Report to the Arlington Redevelopment Board

Recommended Traffic Mitigation Symmes Redevelopment

Arlington Transportation Advisory Committee

11 April 2005

Fig 6. Operation of the Summer Street Corridor at the AM and PM peak hours (Project Built, 2009, signal at Hospital Rd coordinated with Hemlock, Mill optimized but not coordinated, 10% volume increase, signal at Grove and at Oak Hill, Woodside open one-way)

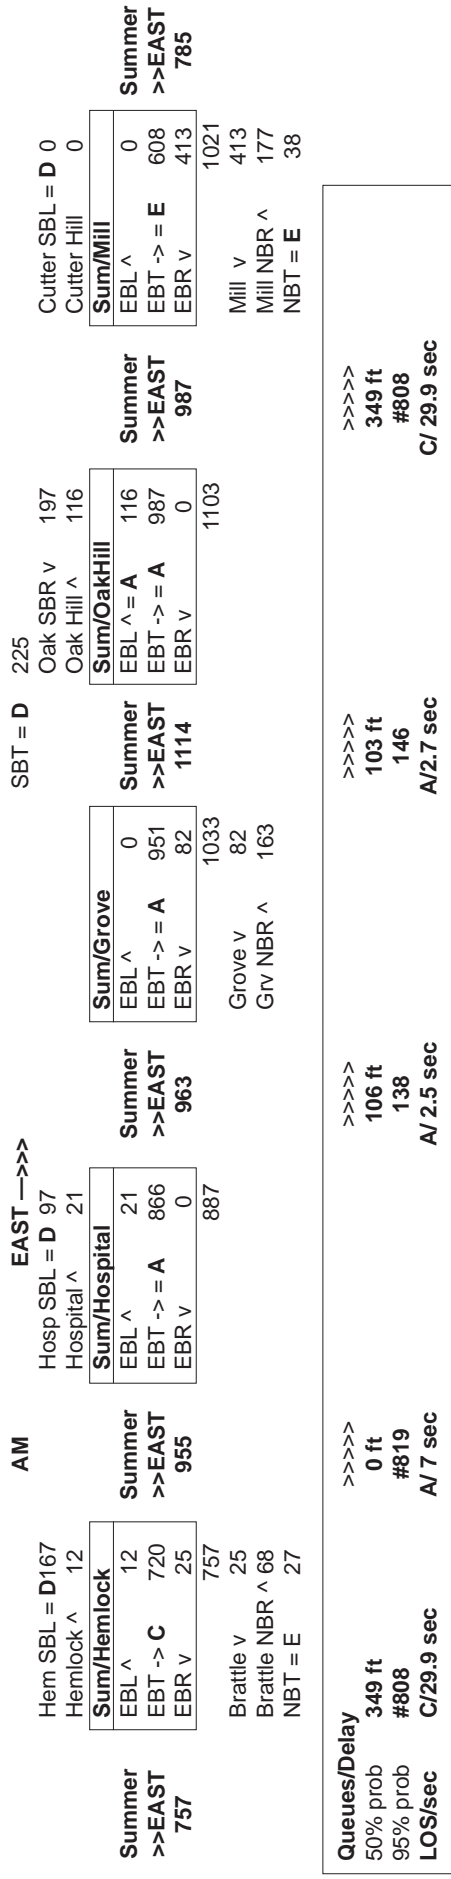
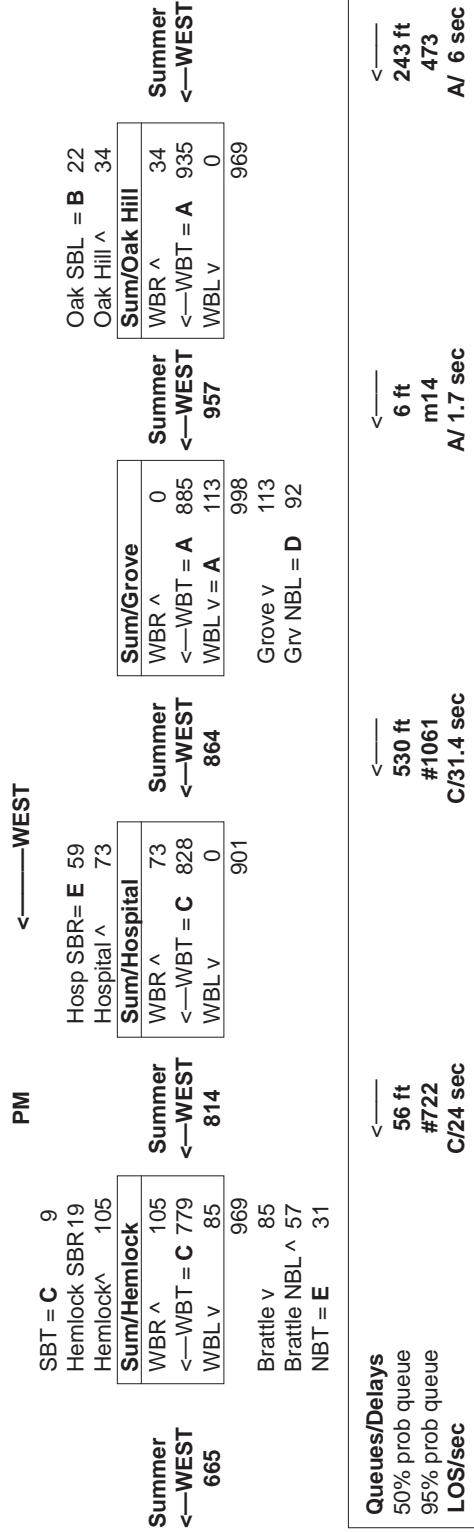
The analyses of the corridor are summarized in Fig 6. Fig 6.1 is eastbound at the AM peak hour and Fig 6.2 is westbound at the PM peak hour.

In these diagrams each intersection is represented by a rectangle. Within the rectangle the traffic volumes for the peak hour in each direction entering the intersection are represented with the LOS if it was given in the analysis. Above the rectangle are the volumes entering and exiting from the street to the north – for example, Hemlock. Below the rectangle are the volumes entering and exiting from the street to the south, for example Brattle. The queues, delays and LOS for the through movement are indicated below the rectangles.

These analyses indicate that the corridor operates satisfactorily at 10% volume, with signals at Grove and Oak Hill, and Mill/Summer optimized but not coordinated. The intersections in this string operate at LOS C-A-A-A-E from east to west in 6.1, and LOS A-A-C-C from west to east in 6.2 (Mill was not analyzed). The LOS E eastbound for the Mill/Summer/Cutter Hill intersection is the same as the current operation in the morning. The only apparent difficulty is the queue westbound in the PM at Hospital Road backing up to and blocking Grove Street. There is 440 ft between the east edge of Hospital Road and the west edge of Grove Street. The 50% probable westbound queue is 530 ft. This will be discussed in a later section when a right turn pocket westbound into Hospital Road is discussed.

Fig 7 Operation of the Summer Street Corridor Eastbound at the AM peak hour (Project Built, 2009, signals on Summer Street at Mill St, Oak Hill Dr, Grove St, Hospital and Brattle St, Woodside open one-way)

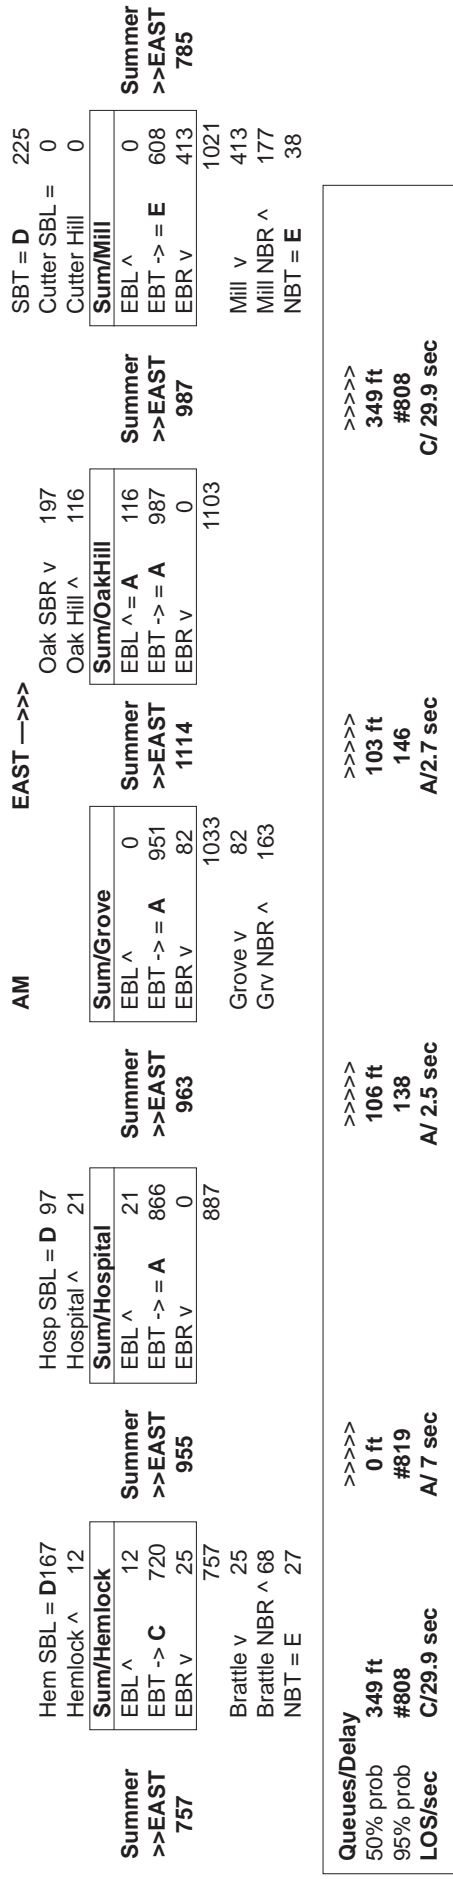
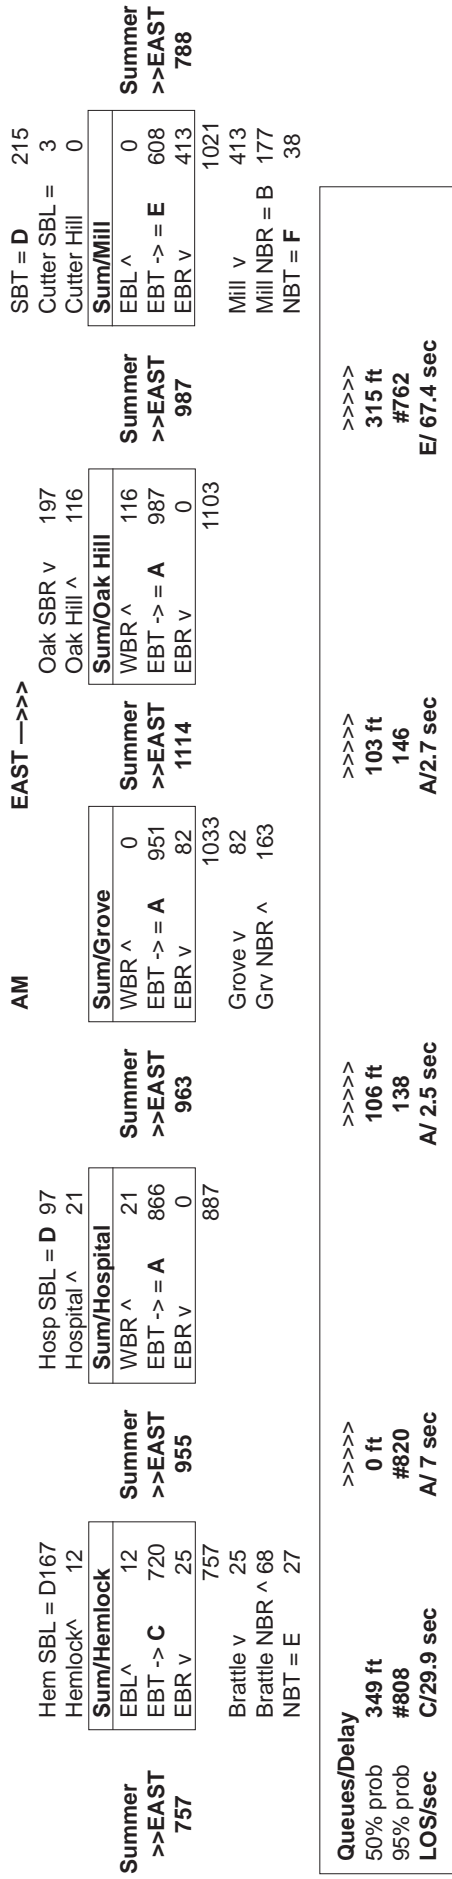
Fig 7 illustrates a sample of the results from analyses of coordination of all signals in the corridor. Fig 7.1 is AM peak hour eastbound without the Mill/Summer intersection added to the coordination, and Fig 7.2 is with it added to the coordination.

Coordinating the Mill/Summer intersection with the other signals makes a little difference to the rest of the corridor, but degrades the performance at Mill/Summer. This coordination does not help and is not recommended.

Fig 8. FST Potential Pedestrian Crossing/Calmng Concept at Summer Street and Oak Hill Drive

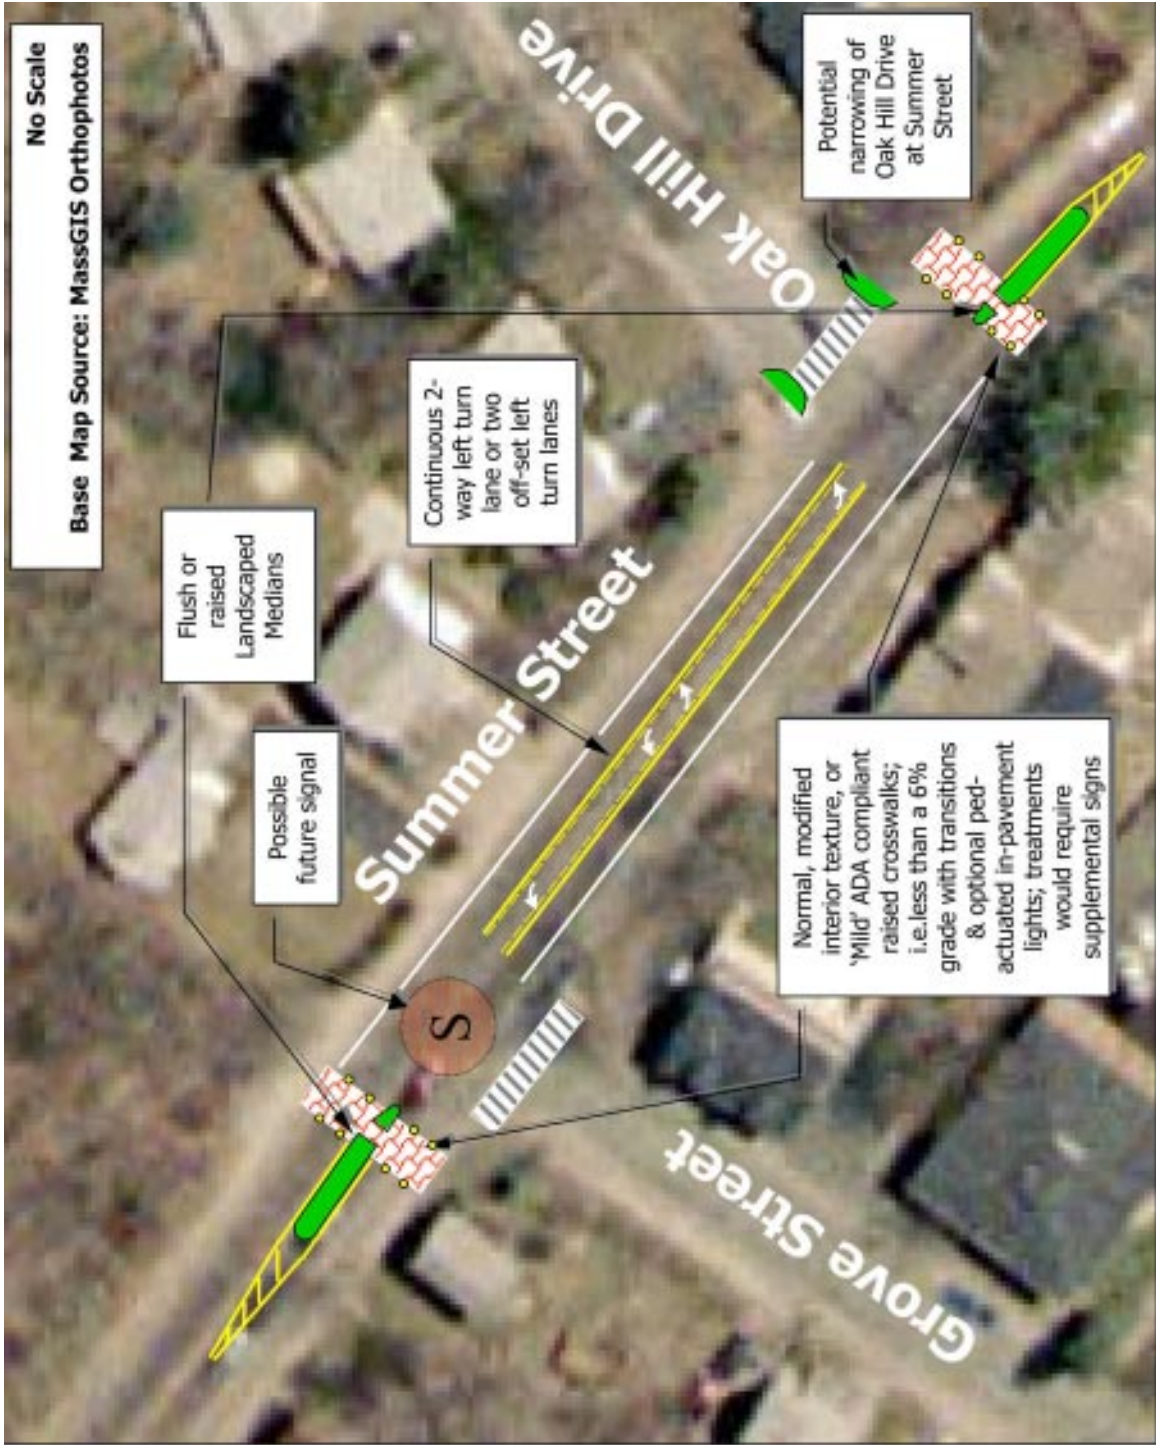
Another option suggested by FST is a set of traffic calming and pedestrian assistance measures to improve safety without a signal. A modification of this suggestion would be traffic islands placed on the eastbound approach to Grove and the westbound approach to Oak Hill. Crosswalks would be installed at the intersection side of each of the islands. In the 150 ft between the intersections, a middle lane would be marked-off that could be used for left turns from either direction. Fig. 8 from FST illustrates this concept.

Recommendation A.3 Adopt a phased approach for the Summer/Grove and Summer/Oak Hill intersections. Phase 1) Traffic calming measures to include refuge islands and crosswalks at Grove and Oak Hill; Phase 2) If needed, signal at Grove Street coordinated with the signals at Summer/Hospital/Brattle.

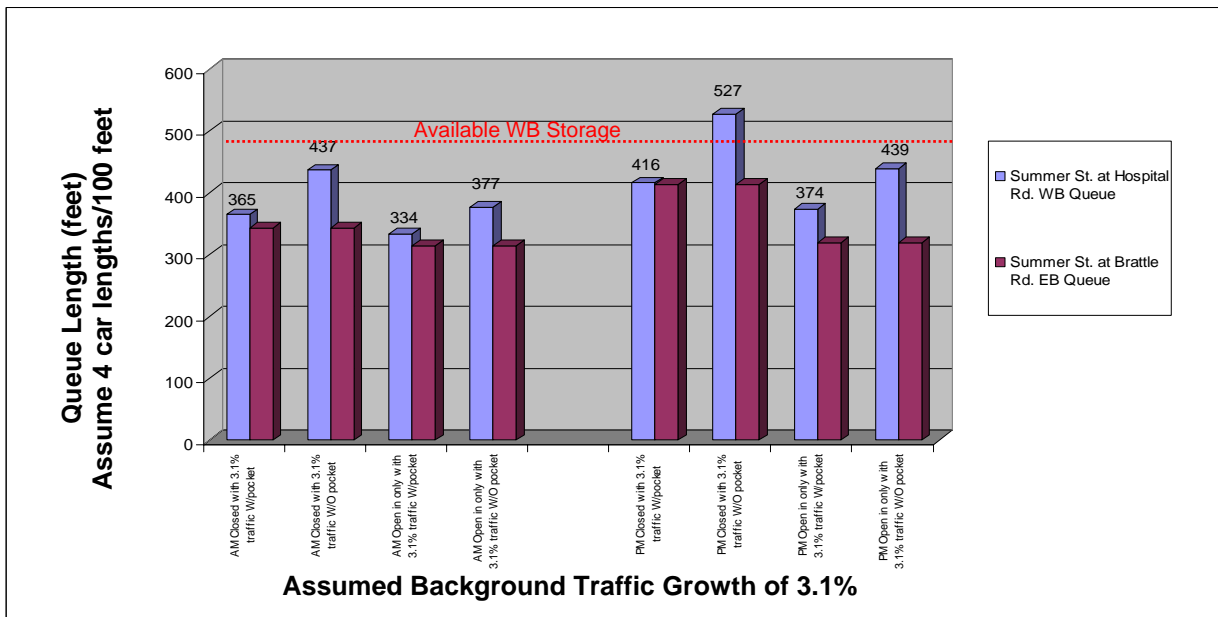
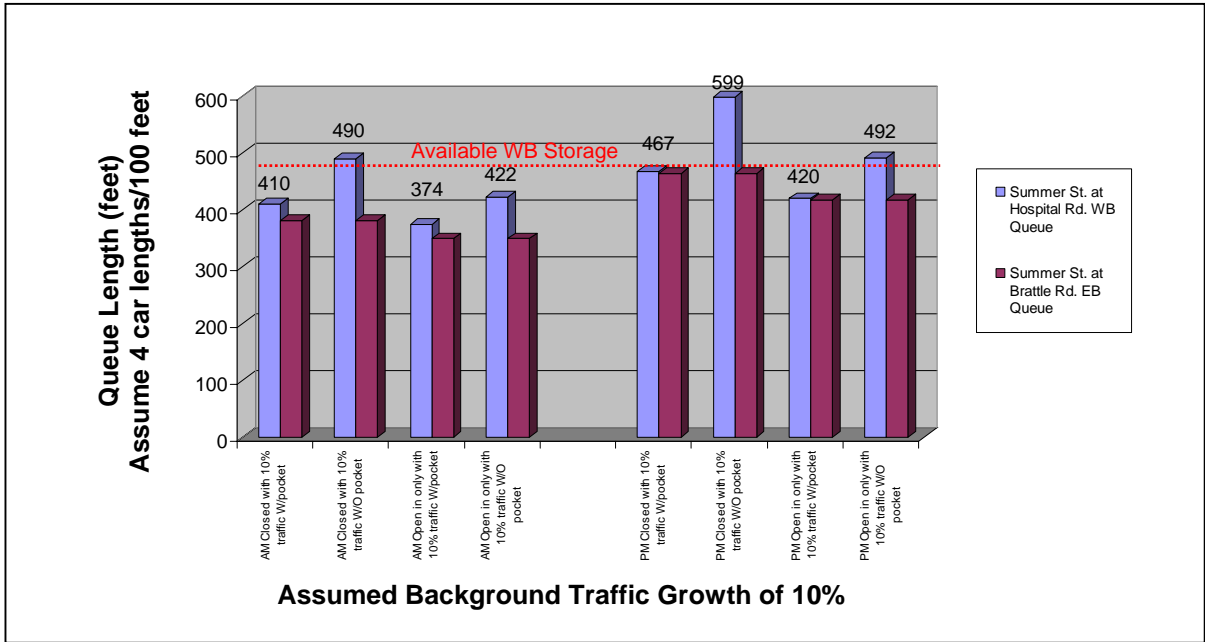
Issue 1 - The proposed 200-foot long right turn pocket on the north side of Summer Street approaching Hospital Road:

- The proposed turn pocket has environmental issues (removal of a couple of trees and green space) that may offset its traffic benefits.
- With the assumed Summer Street background growth totaling 3.1% to the design year, it is concluded that the addition of the right turn pocket lane typically reduces the AM and PM peak hour queues on Summer Street by approximately 2-4 car lengths depending on whether Woodside Lane is open or closed.
- With an assumed Summer Street background growth totaling 10% to the design year (also refer to the chart on the next page, it is concluded that the addition of the right turn pocket lane typically reduces the AM and PM peak hour traffic queues on Summer Street by approximately 3-5 car lengths. (refer to charts on the page that follows).

Based on the historical Summer Street traffic volumes, it is not unreasonable to assume that Summer Street may at some point carry traffic volumes similar to those it carried several years ago. Even with a 10% assumed growth in traffic on Summer Street, its traffic can grow approximately another 15-20% during peak hours in the peak flow direction before the corridor becomes saturated.

Conclusion: The right turn pocket is beneficial from a traffic perspective, as it reduces queues toward Grove Street. The question is the trade-off between the green space lost vs. the reduced traffic queues. This is a community value issue. Similarly, with Woodside Lane open one-way to Symmes inbound traffic, the difference in queuing with the right turn pocket is approximately 1-2 car lengths. With Woodside Lane closed to all Symmes traffic, the difference in queuing is 2-3 car lengths without the turn pocket.

Woodside Lane looking east at Hospital Road

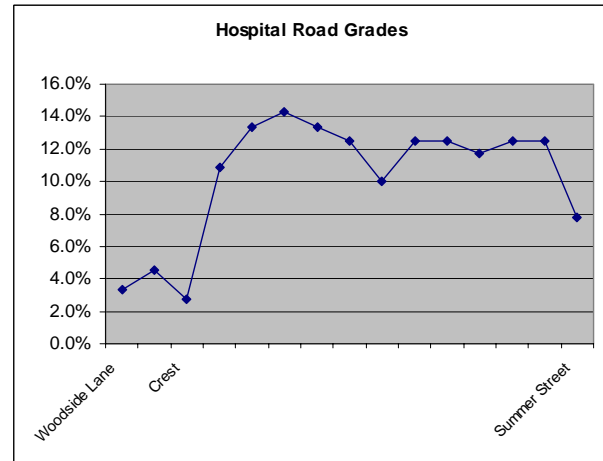
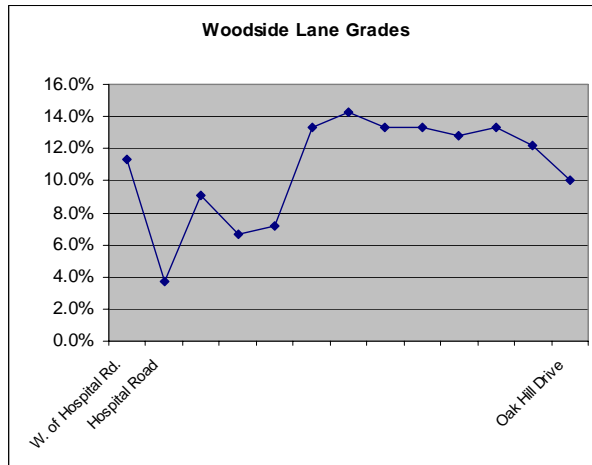
Conclusion: During our initial review, FST recommended that Woodside Lane provide emergency, pedestrian, and bicycle access. We see no reason to change this recommendation in light of its constricted geometric and sight line conditions and its functional capacity. We note that emergency access means that there must not be a locked gate, according to recent Arlington Deputy Fire Chief discussions with the TAC.

Potentially, *restricting inbound access to less than 40 vehicles per hour during peak hours* from Woodside Lane is a reasonable option that can be considered for testing if monitoring equipment is installed at the Woodside Lane entrance and the findings are regularly made available to Woodside Lane neighbors.

As part of a mitigation strategy, the Proponent should provide a shared sidewalk/bikepath into the site from Woodside Lane. A sidewalk should be provided at minimum on one side of Hospital Drive along its entire length, probably the east side is most appropriate given the location of the high school and Town Center. If technically feasible, it would be preferable to have sidewalks on both sides of Hospital Road. It is important to understand that these sidewalks will not meet ADA minimum grade requirements due to the natural steep grades in the area and may require railings in areas where grades are steeper than 8.6% -- virtually the entire length. A sidewalk should also be provided on the north side of Summer Street between the site and the bikeway crossing of Summer Street. The bikeway crossing of Summer Street should also be addressed with a special pedestrian crossing treatment. The substandard sidewalk on the north side of Summer Street between Oak Hill Drive and the bike crossing should be improved concurrently. On Woodside Lane, consider the provision of a sidewalk on the south side to the east side of Brattle as far as Millet Street, if feasible within the available right-of-way and acceptable to direct abutters.

Table 2. Block Time

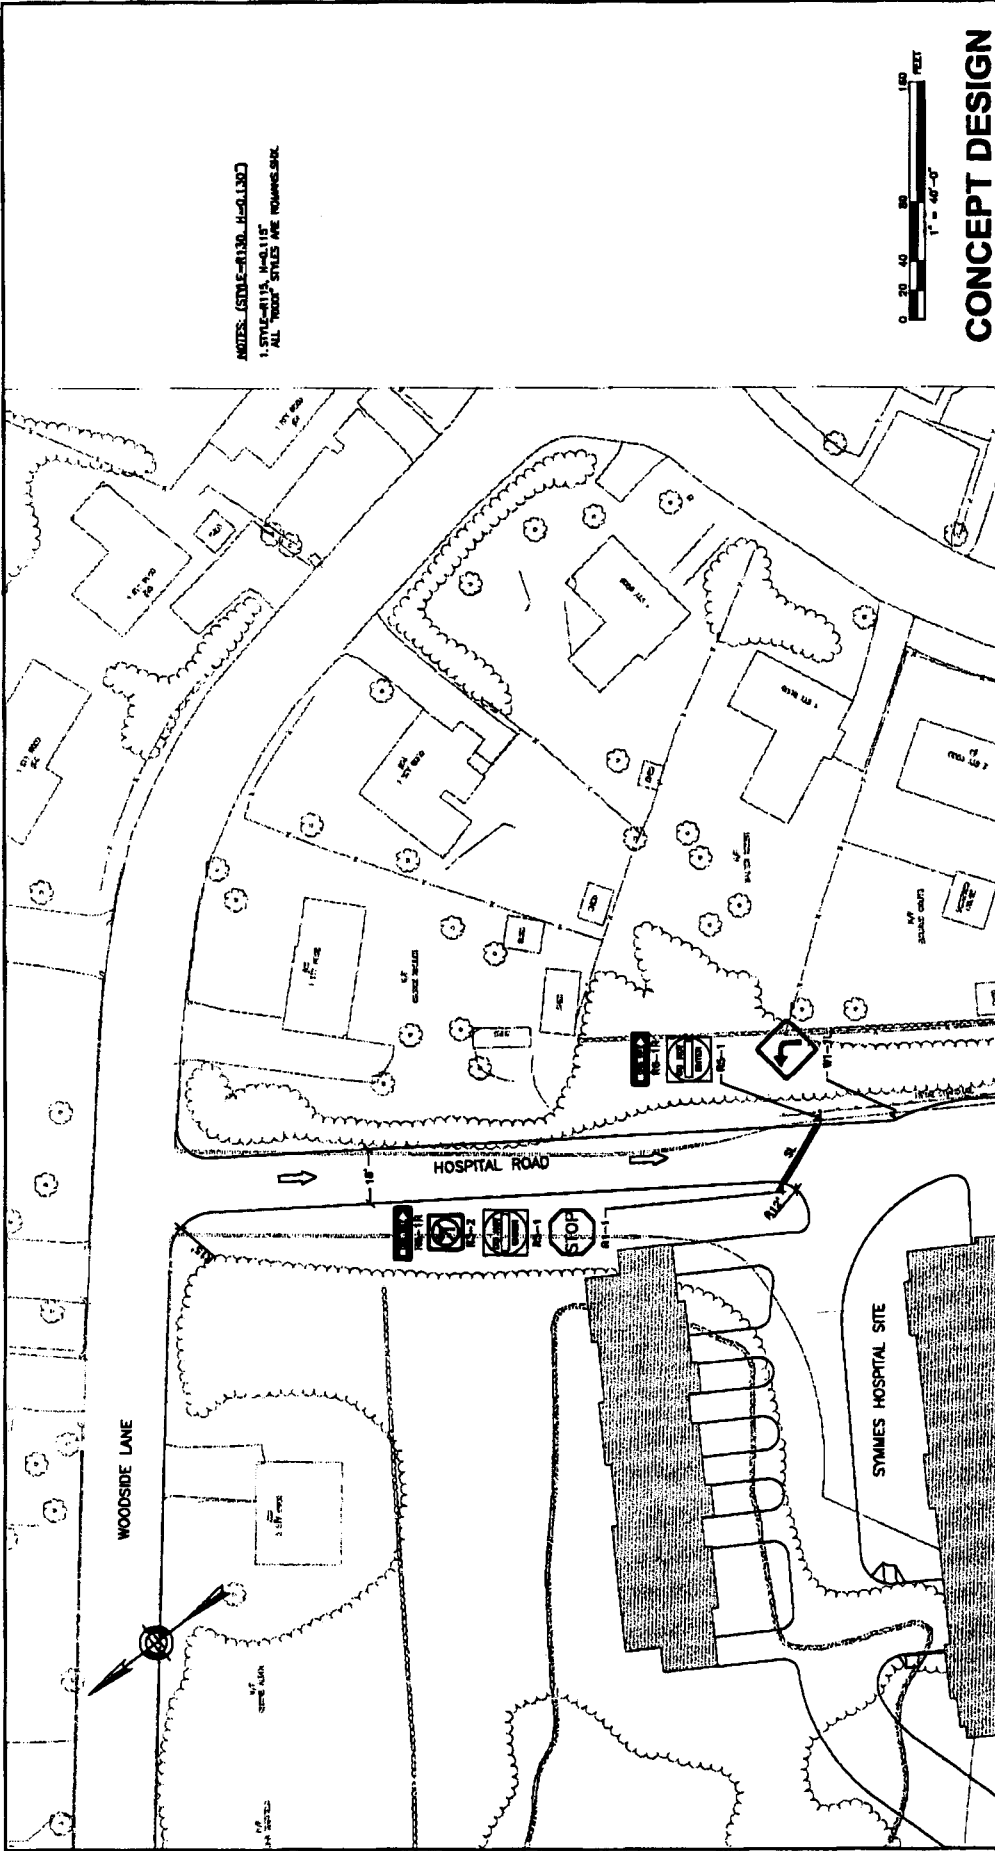
As shown in the table, the turn-pocket will be blocked by traffic in the thru lane and not fully utilized between 9-25% of the time during 50th percentile traffic periods and 49-63% of the time during 95th percentile traffic periods.
